ADDENDUM 1

**TUCKAHOE MIDDLE/HIGH SCHOOL
ALTERATIONS**
TUCKAHOE UNION FREE SCHOOL DISTRICT

S.E.D. Control No. 66-03-02-03-0-002-024

Job No.
2021-1053
Date
04/19/2022
Scale
1/8" = 1'-0"
Drawn / Checked
Author

Sheet No.
ASK-01

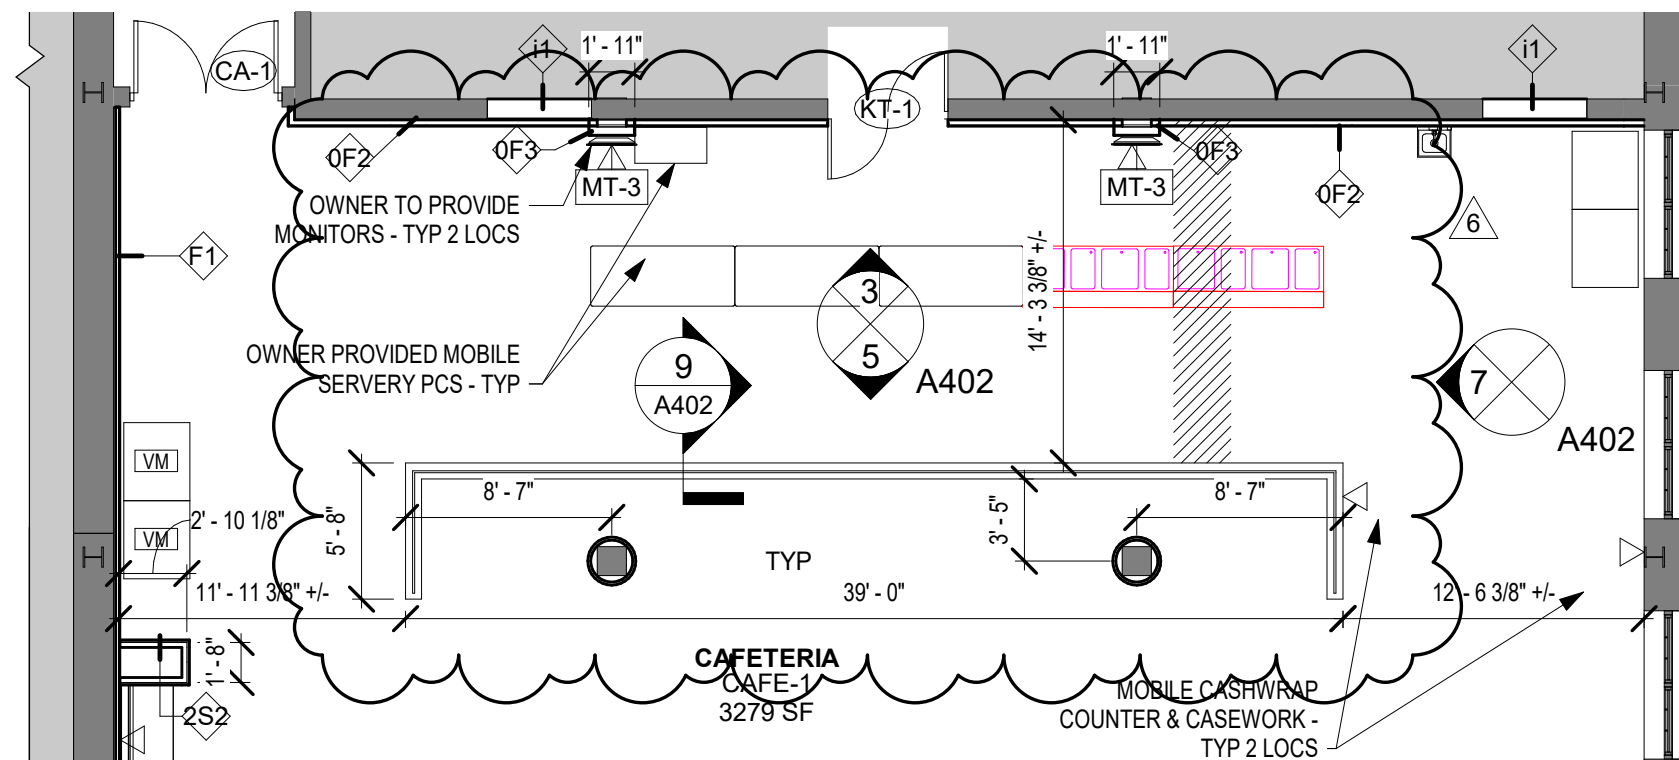
- b. Demolition Keynote Schedule – remove any reference to Demolition Keynotes 24, 25 & 26.
 3. Drawing A105 Enlarged Demolition Plans & Sections
 - a. Plan 1/A105 – extended saw cut trench from 12'-8" to 14'-8" – see attached ASK-01

4. Drawing A401 Enlarged Plans
 - a. Removed 'H2' window from Media Center room # 263A – see attached ASK-03
 - b. Relocated Cafeteria half wall 2'-0" closer to columns – see attached ASK-01

- c. Extended Cafeteria floor trench patch 2'-0" 1/A401– see attached ASK-01
 - d. Add Monitor Device Elevation – see attached ASK-04
 - e. Added Glass Marker Boards to Breakout Rooms SV-2, 3, 4 & 5 and V-101 – see attached ASK-02

Sheet No.
ASK-02

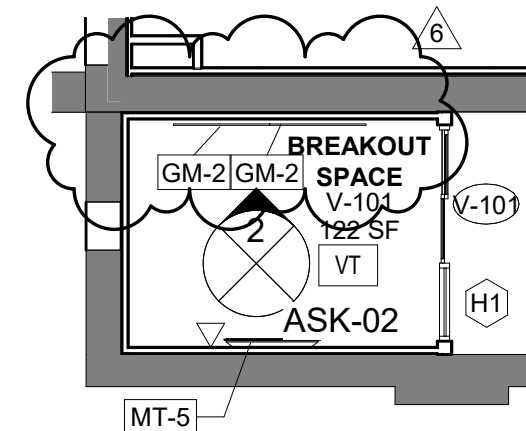
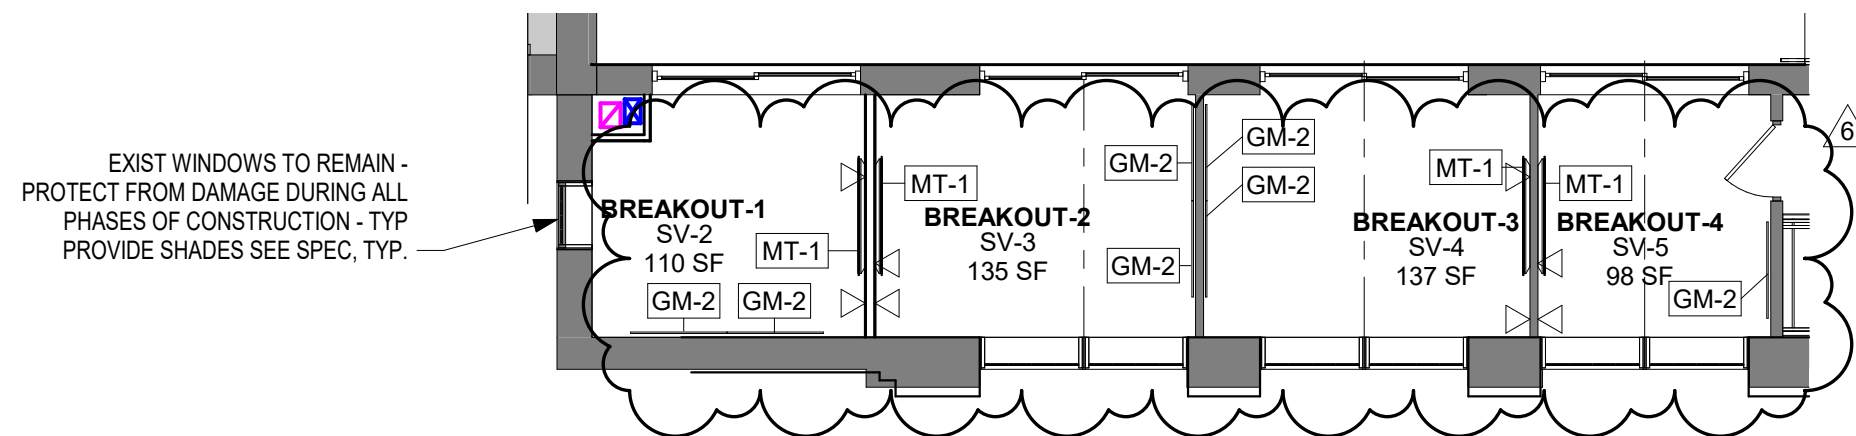
- g. Added Roller Shade note to Breakout-1 Room SV-2 – see attached ASK-02
 5. Drawing A403 Vestibule and Library Elevations & Details
 - a. Remove 'H2' window from Elevation 6/A403 – see attached ASK-03

Sheet No.
ASK-05

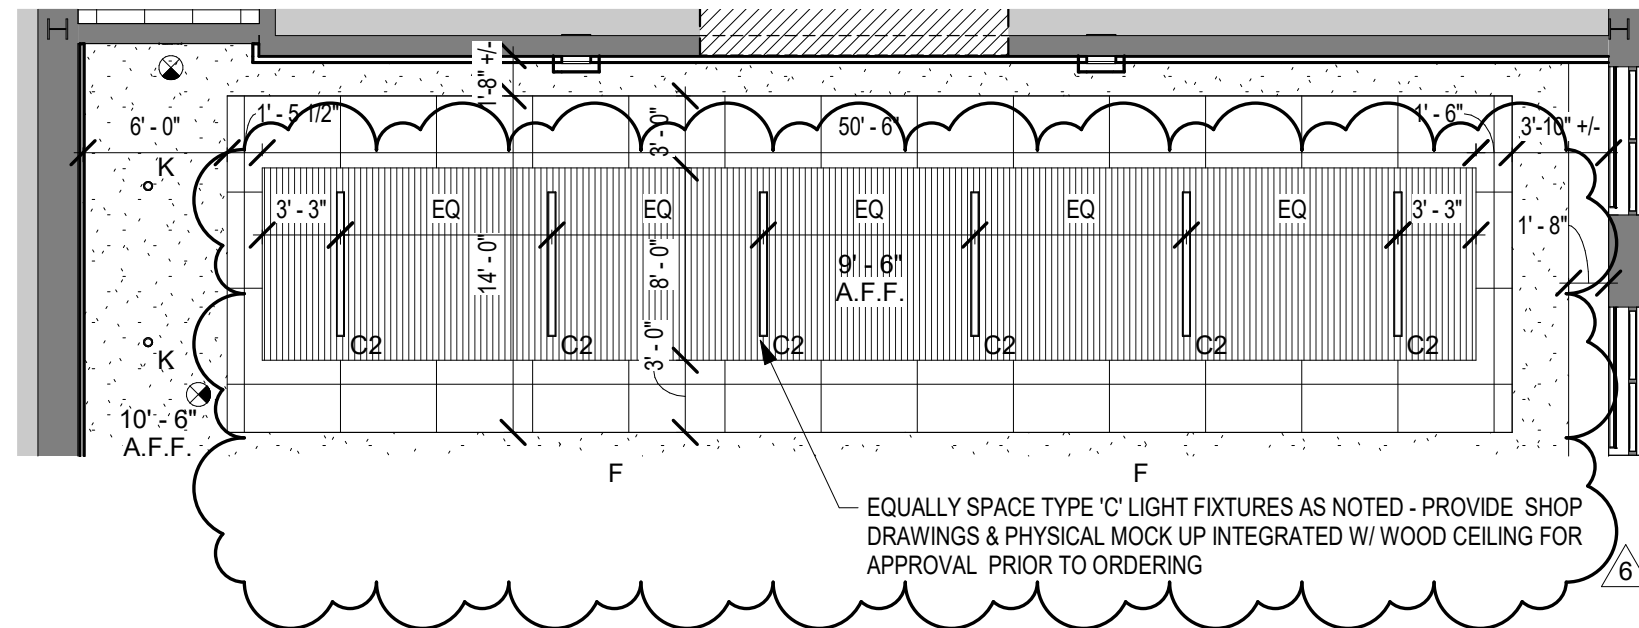
6. Drawing A601 Enlarged RCPS
 - a. 1/A601 Cafeteria RCP – Relocated light fixture Type C in plan and added noted – see attached ASK-05
 - b. 2/A601 Partial Vestibule RCP – added (4) Type 'B' light fixtures to Breakout Space V-101
